# Service Bulletin

**SUBJECT:** Service Update for Inventory and Customer Vehicles  
Incorrect Windshield Installed with Head Up Display (HUD)  
Expires with Base Warranty

**MODELS:** 2015 Cadillac Escalade, Escalade ESV  
Equipped with Head Up Display (HUD) RPO (UV6)

Subject: 15276 – Service Update Bulletin  
Incorrect Windshield Installed with Head Up Display (HUD)

4140768

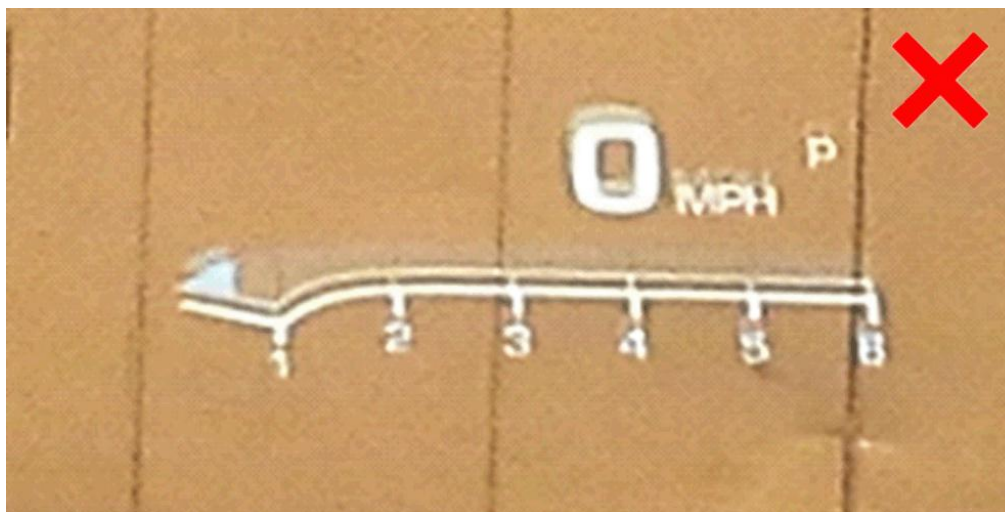
1. Inspect the front windshield for a “blurry” HUD image.

- If the front windshield does NOT display a blurry HUD image, no further action is required. The photograph with a check mark is an acceptable HUD image.

- If the front windshield displays a blurry HUD image, replace the front windshield. Proceed to step 2. The photograph with an 'X' is blurry and NOT an acceptable HUD image.

- BO-39032 Stationary Glass Removal Tool
  - Use a urethane adhesive systems which meet GM Specification GMW 15672
2. Replace the front windshield. Refer to *Windshield Replacement* in SI.
